SECOND REVISION
PLAN COMMISSION
MEETING NOTICE AND AGENDA
Thursday, September 21, 2023
6:00 PM

Project Name: WVRC Conditional Use, Rezoning, and Site & Building Plans

IMPROVEMENT PLANS FOR
WVRC EMERGENCY VET
CITY OF PEWAUKEE, WI

PLAN DATE 03.04.19
DESIGNED BY DKV

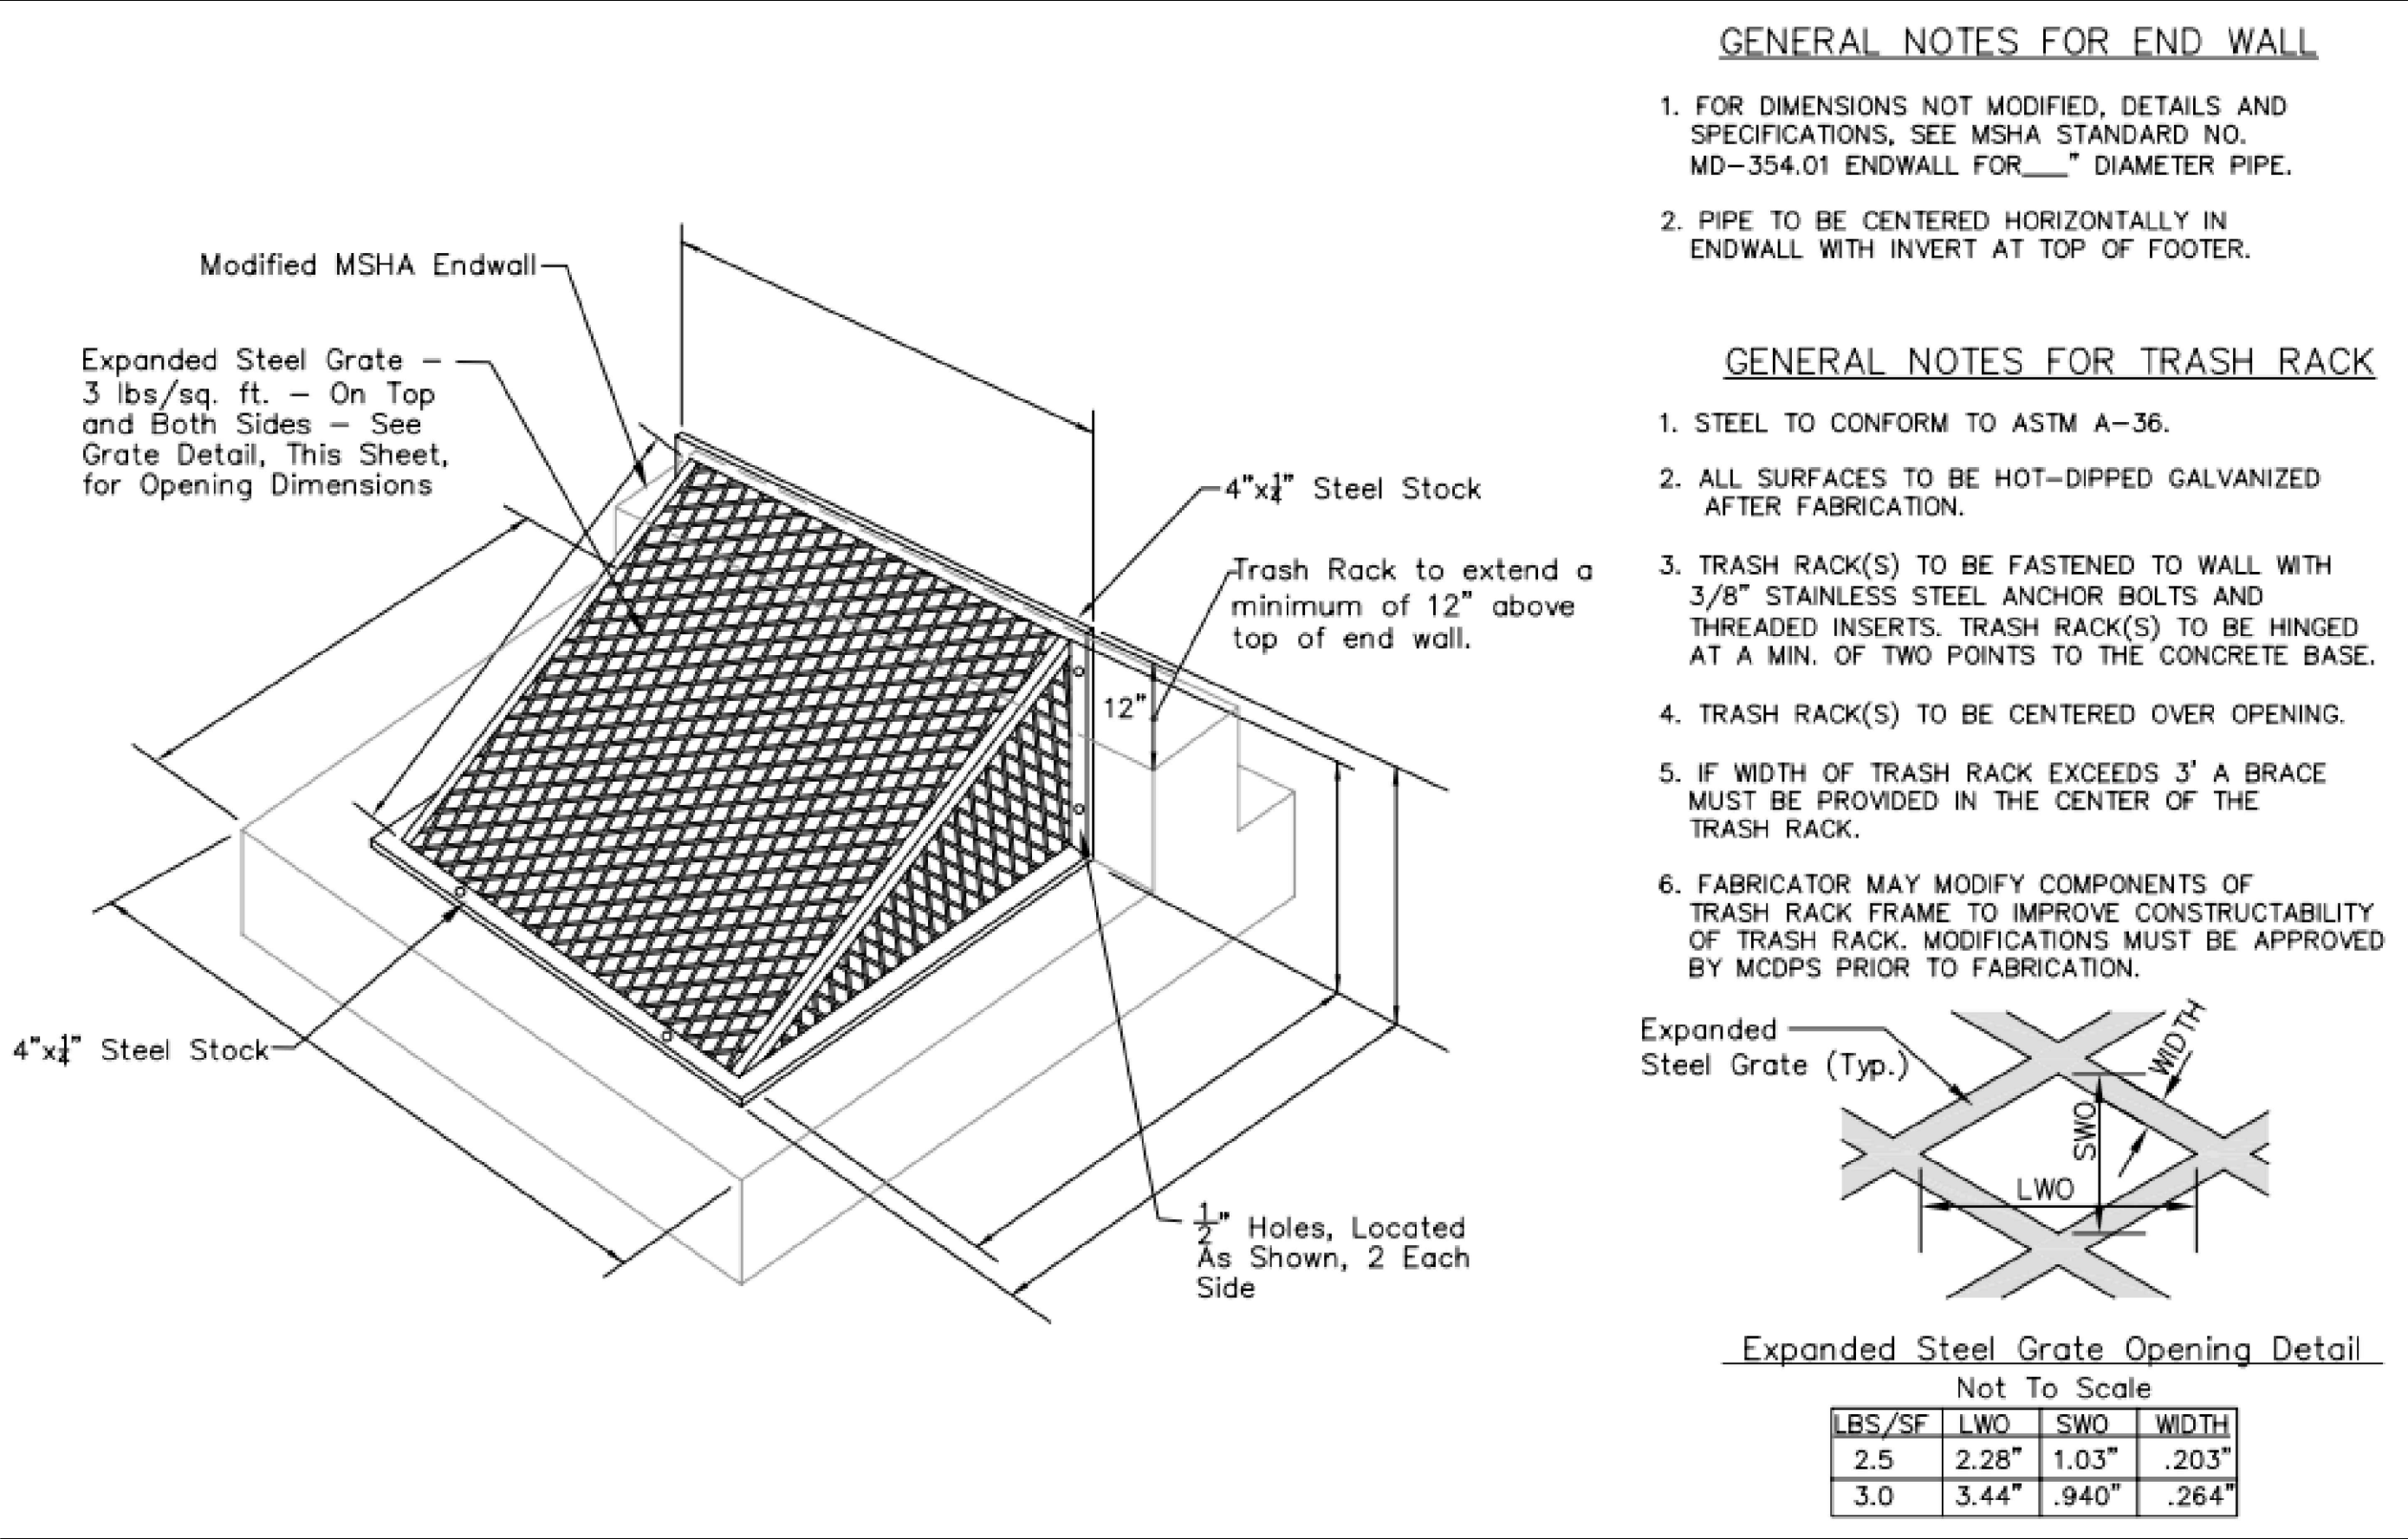
1. Show the location and details for the proposed concrete washout on site. **Concrete washout has been added to sheet C103, and a detail has been added to sheet C503.**
2. Revise inlet protection detail to show type A and type D inlet protection. All inlet protection placed on site should be type A or type D. **Inlet protections details for type A and D have been added to sheet C501.**
3. Include a detail for the proposed orifice trash grate. **Detail has been added to sheet C503.**
4. Revise the end section and riprap detail to show placement of medium riprap following the flared end section. **Detail has been updated from light riprap to medium riprap.**
